Analysis of Feasibility Study – AKL Domestic Terminal Options

19 December 2023

Air New Zealand/ARUP study - “Findings of Feasibility Study – AKL Domestic Terminal Options” – 31st Oct 2023

Airfield layout

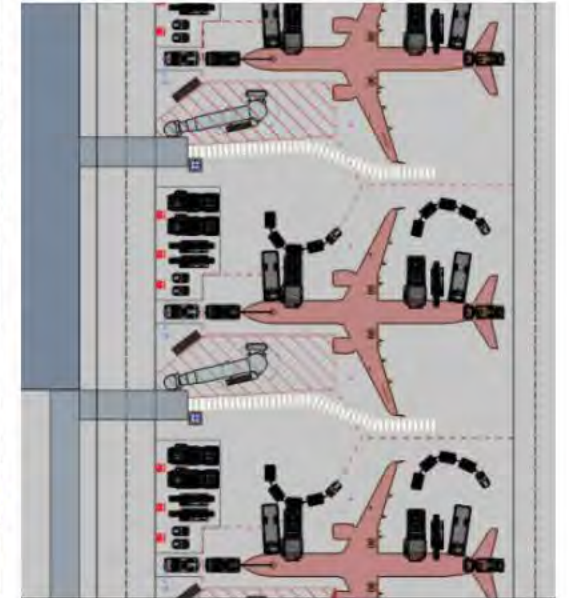
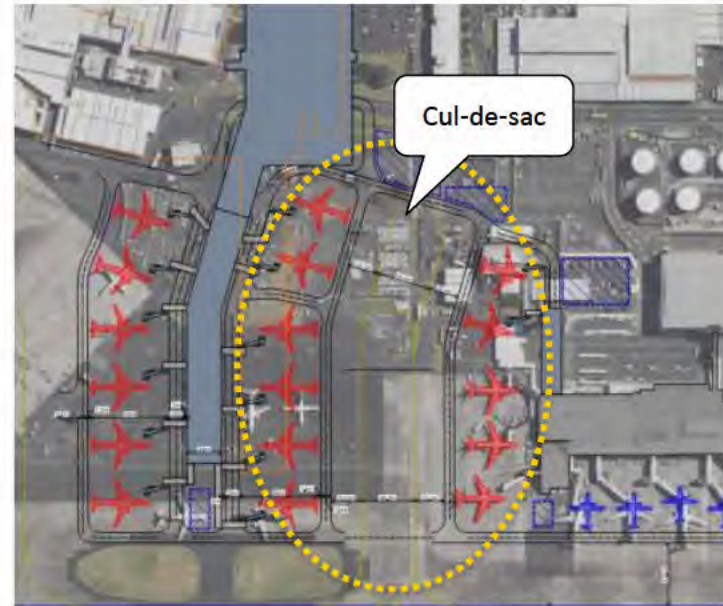
The ADT proposes 12 code C stands operated from Pier A1, 6 per side. Passenger Boarding Bridges (“PBB”) are available at each stand. The design is also proposing that rear boarding would be available for each stand. This is in line with the DP design.

The ADT “offset” design is proposing a dual taxi lane between Pier A1 and DTB. This has been explained as required to minimise delays on the cul-de-sac . The DP Design is delivering one taxilane.

To allow for a dual taxilane, the Air New Zealand Pier A1 layout shifts part of the pier closer to Pier A, in a similar position to the design for the Pier proposed in 2018.

The single taxiway approach on the eastern side of Pier A1 was presented for the first time in the 2014 Master Plan (staging pathway) and has been part of the design ever since.

In 2018 Mott MacDonald shared a benchmark of international airports running cul-de-sac operations with a single taxiway/taxilane, showing that up to 14 stands were managed in a cul-de-sac. The main challenges this operation presented was around jet blast impact on GSE and passengers (in case of rear boarding procedures).

CUL-DE-SAC OPERATIONS TWY D-D1 (PIER A1 – DTB)

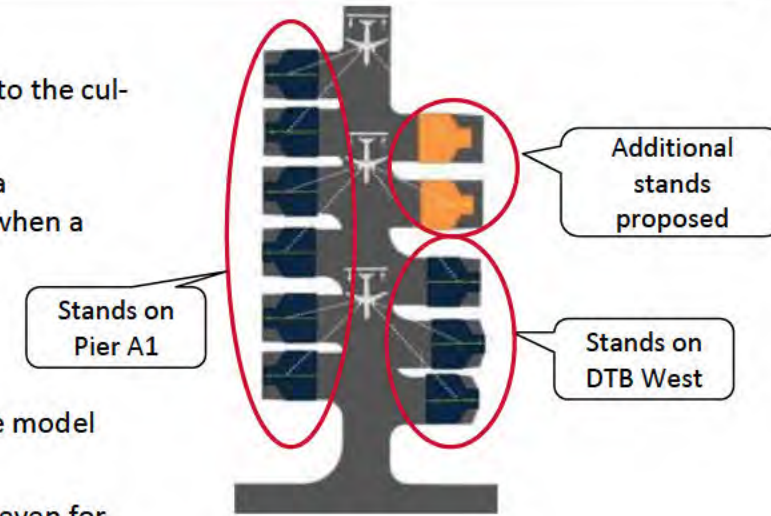
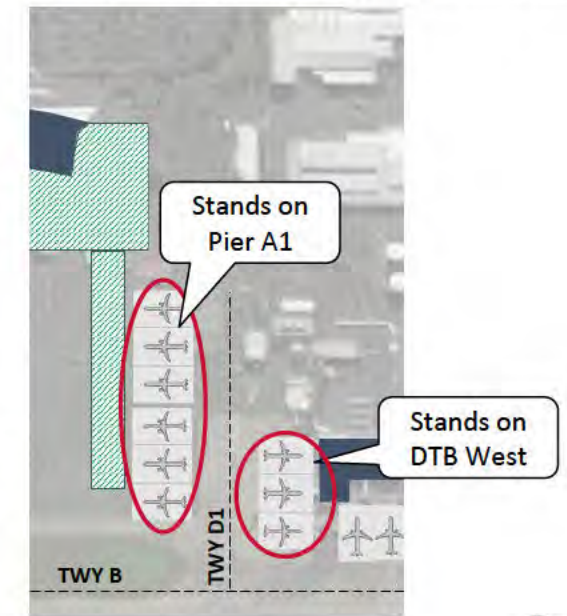
Air New Zealand presented results from a CAST model prepared by ARUP on TWY D cul-de-sac operations. The model is limited to the cul-de-sac only.

It is noted that the scenario modelled considered 11 stands served by one taxilane. Auckland Airport proposed DP would serve a maximum of 9 code C from a single taxilane. It is envisaged that additional stands on the Pier A2 alignment would be built only when a dual taxi-lane is in place. This means that:

- In 2033 only 9 stands are served by a single taxilane (TWYD1)
- in 2043 a dual-taxilane (TWYD2) would be in place.

Auckland Airport modelled the TWY D cul-de-sac in 2018 and again in 2023 when the updated set of forecasts was released. The model takes into consideration the totality of airfield operations, it is therefore not limited to the cul-de-sac only.

The outcomes from the latest modelling suggest that TWY D1 cul-de-sac will not compromise operations (for the 9 stands), and even for the stress case demand (FY33), delay figures are acceptable. In particular:

- Delays at the cul-de-sac show negligible values in FY28 with an average of 2min in the peak hour. Per-minute observations show a cumulative delay of 2min, experienced by a total of 3 aircraft. This leads to an average wait of 40 sec.
- The values increase for FY33 to an average of 4min in the rolling hour. Per-minute observations show a cumulative delay of 2min, experienced by a total of 4 aircraft. This leads to an average wait of 30 sec.
- The conflicts observed follow a similar pattern, with a departing aircraft generating congestion following engine start processes at the entrance of TWY D1, blocking arriving aircraft, leading to queue building up on TWYB. Operations mitigation could be considered on a case-by-case basis.
- The area therefore does not flag up as a key congestion location in the airfield, with most delays occurring along TWY A & B and at runway entry locations.

The cumulative delays Air New Zealand is referring to in the document provided to Auckland Airport are related to **overall ground delays**. It is observed that the scheduled forecasted for FY33 shows off-peak period demand very close to the observed runway capacity. This leads to a high utilisation of some of the taxiways (in particular TWY A and TWYB to access the runway). Pushbacks from DTB onto Bravo contribute to the congestion.

TDP layout (2018) and ADT proposed layout (2023)

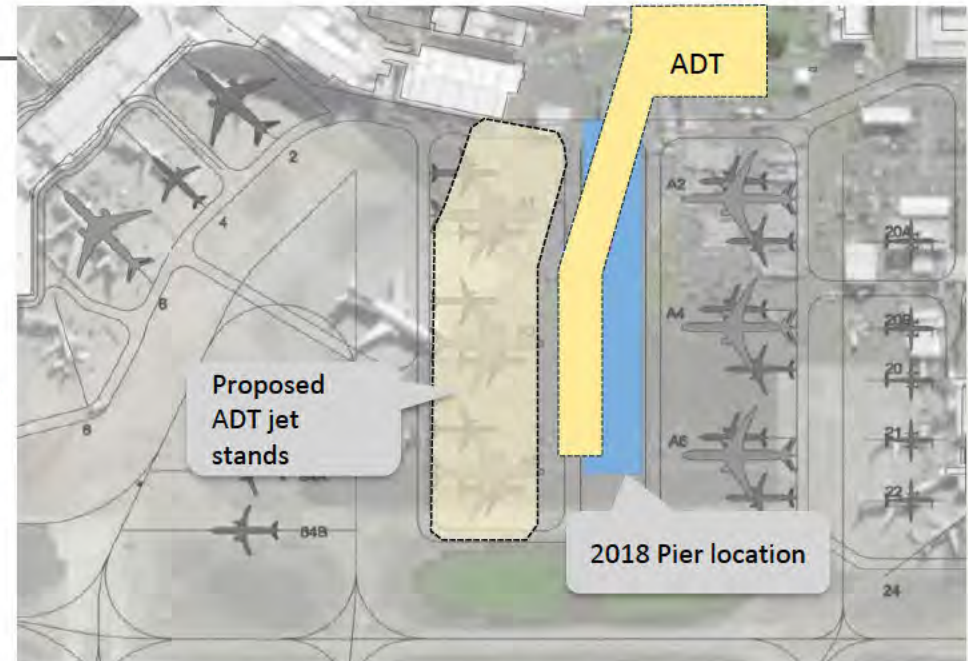
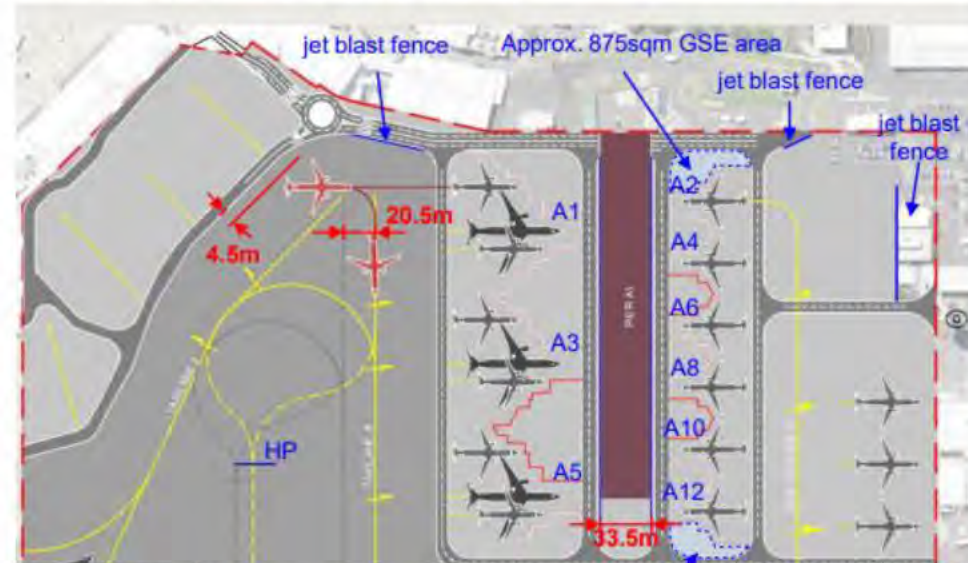
The layout proposed by Air New Zealand is re-shifting Pier A1 to a very similar location to the original 2018 design. This would therefore propose the same challenges identified in 2018.

In 2018, with the commencement of the Terminal Development Programme (TDP) Design Auckland Airport commissioned a study to Mott MacDonald to determine jet blast constraints for aircraft manoeuvring between the east side of Pier A and the east side of Pier A1, and between the east side of Pier A1 and the DTB.

The study identified challenges in some operations between Pier A and A1 due to jet blasts on arrival and concluded that procedures were required to mitigate the jet blast issues on arrival, including restricting stands on Pier A, use of jet blast barriers and possible restriction on rear boarding operations for some of the stands.

Challenges were identified on departure as well, with long pushback and long operations from some of the Pier A west and Pier A1 eastern stands.

Due to the concerns around the number of mitigations required to safely operate the cul-de-sac between Pier A and Pier A1, a Key Decision Memorandum (KDM) exercise was undertaken and subsequently a number of changes have been implemented to the design, such as:

- the reduction in pier width, (from 40m to 33.5m) and subsequent changes to the stand location
- the shift of Pier A1 c.ca 20m to the east to allow for straight pushback from stands A1, reducing the impact of the jet blast on the stands located on the eastern side of A1 and allowing for rear boarding operations
- the implementation of a code E capable holding point (HP) in the cul-de-sac J-J1 to enhance ground movement e.g. freeing circulation space on TWY B.
- change in depth from Code E to C stands on the western side of Pier A1
- additional GSE staging/parking areas on Pier A1 eastern apron

ADDITIONAL STANDS ON DTB WESTERN SIDE

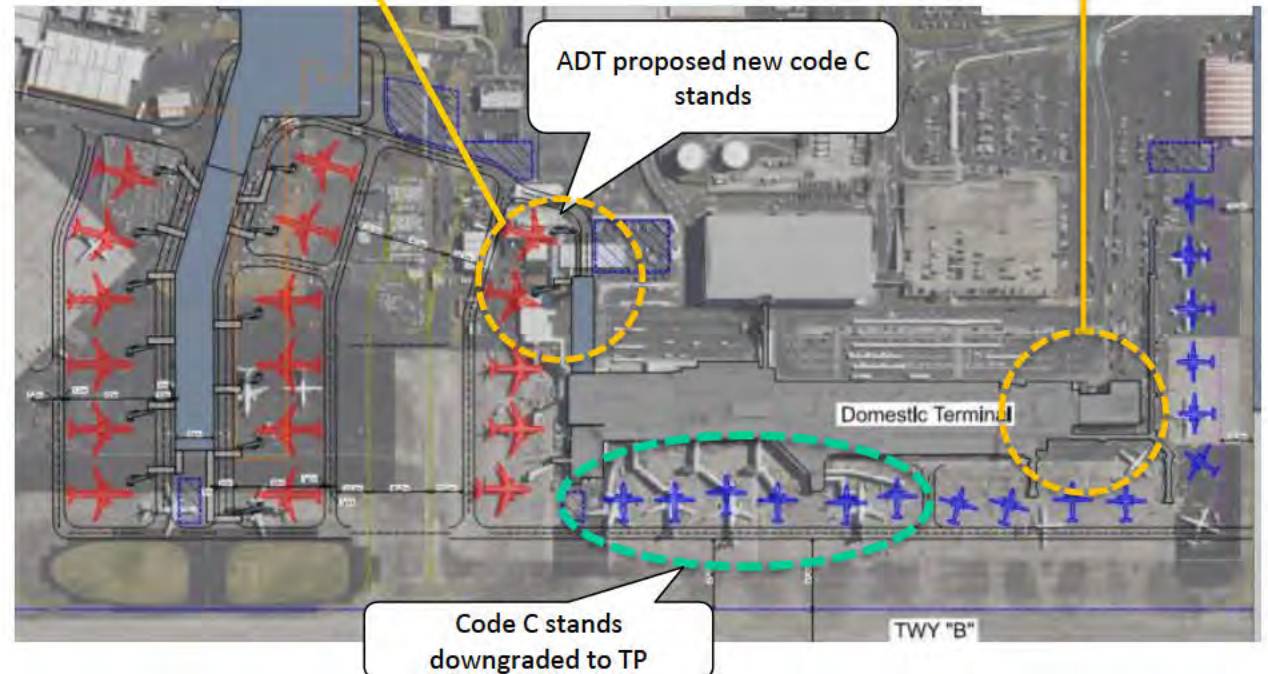
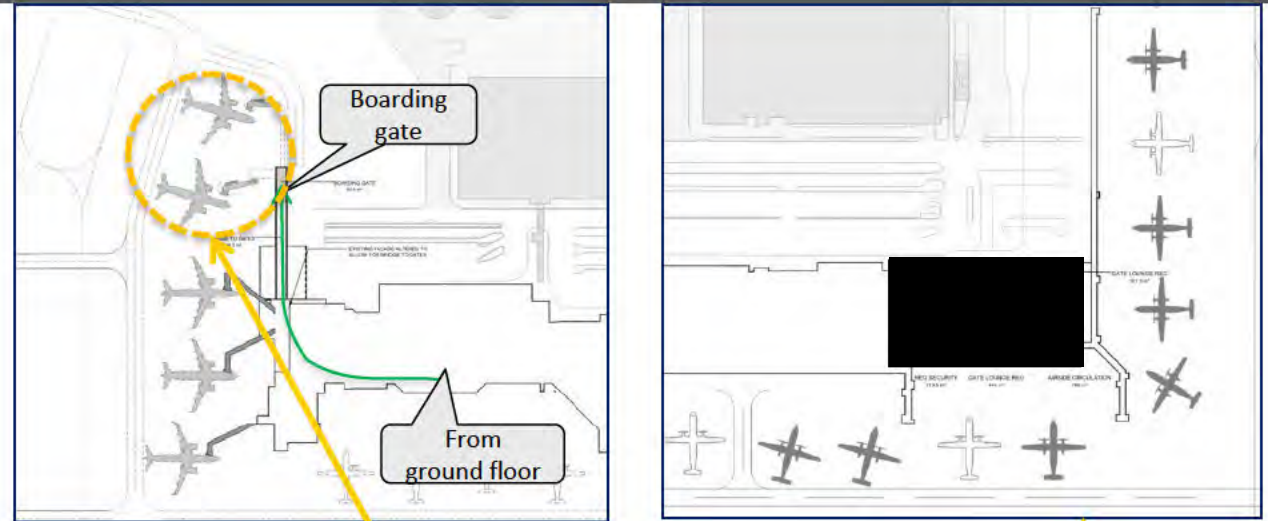
- ADT proposes 2 new code C stands located north of the current DTB western stands. A walkway from DTL level 1 would connect the existing terminal to the stands.

- The current terminal would be linked to the stands via a walkway from DTB level 1. A boarding gate of 93m² is proposed at the end of the walkway to service both stands. It is assumed that pax will keep using the existing airside dwell area.

- The stands and the walkway sit on top of existing infrastructure such as PUDO, Air Traffic Control ("ATC") tower and Oceanic Building.
- ADT suggests locating the future regional screening on the eastern side of DTB and proposes downgrading the code C stands to turboprop stands. Walk-out stands are required for turboprop since the use of PBB is not possible. According to the proposed design both PBB and fixed links are removed from the existing domestic stands.

- There is no mention of how the downgraded code C stands are going to be served. Major work would be necessary to allow passengers to board/disembark since DTB was not designed to service aircraft via walk-out stands.

DP – fixed link, with ramps to rotunda levels and VT to GF
(not at scale)

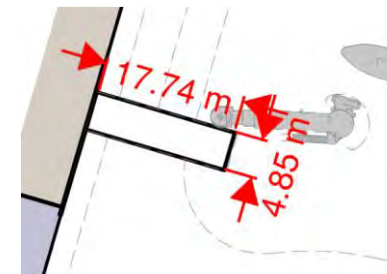
- ADT design does not clarify the slope assigned to the fixed links ramp to the rotunda level nor vertical circulation (“VT”) availability. The layout provided for the ground floor shows no fixed link footprint, making it unclear how rear-boarding operations would be managed.

ADT – fixed links. Ramp details (length/slopes) and VT not provided
(not at scale)

ADT - Not at scale

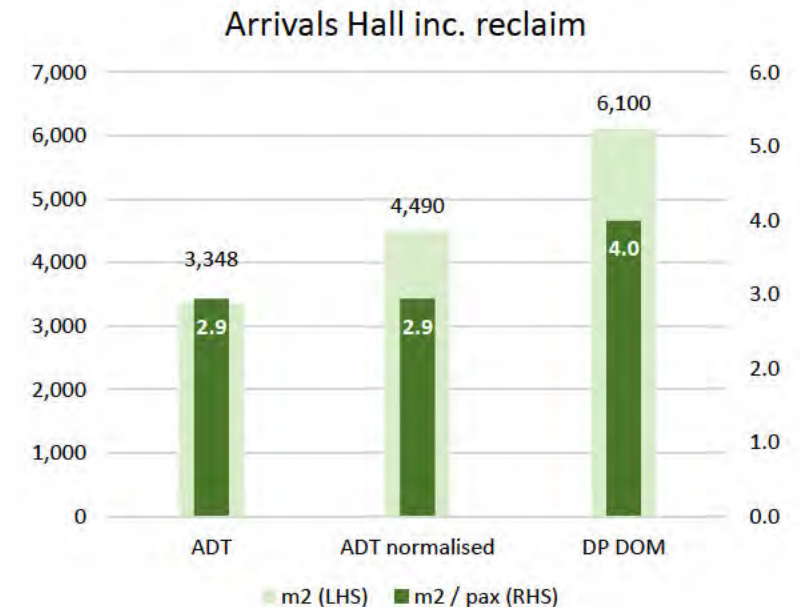
- Both in ADT and DP the arrivals hall space, reclaim hall and meet and greet areas are combined
- DP hall includes pax services such as lost bags offices for the different ground handlers, pets and a dedicated lane for OOG. These services seem to not be available in the ADT design.

- The DP design is proposing baggage carousels fed from above, providing 100% of reclaim frontage. ADT is suggesting back-to-wall belts with an inbound baggage area: it is unclear how unloading for three belts, plus BHS operations rooms and, eventually, plant, would share space in the baggage handling area.

- DP includes a space for three carousels, with two to be installed on day 1. The third carousel will be installed if additional system resiliency is required, or when the demand date for additional capacity is required (currently expected to be before 2037). This future-proofs the space for resilience and expansion without disruption to operations. Removing this space was considered as a potential cost saving as part of the Capital Plan Review in late 2022 consulted with airlines. This cost saving was not supported by Air New Zealand and was not adopted in the final design.

- The provision of space for the third reclaim belt largely explains the c. 1,600m² difference between the DP design and the normalised ADT floorplate
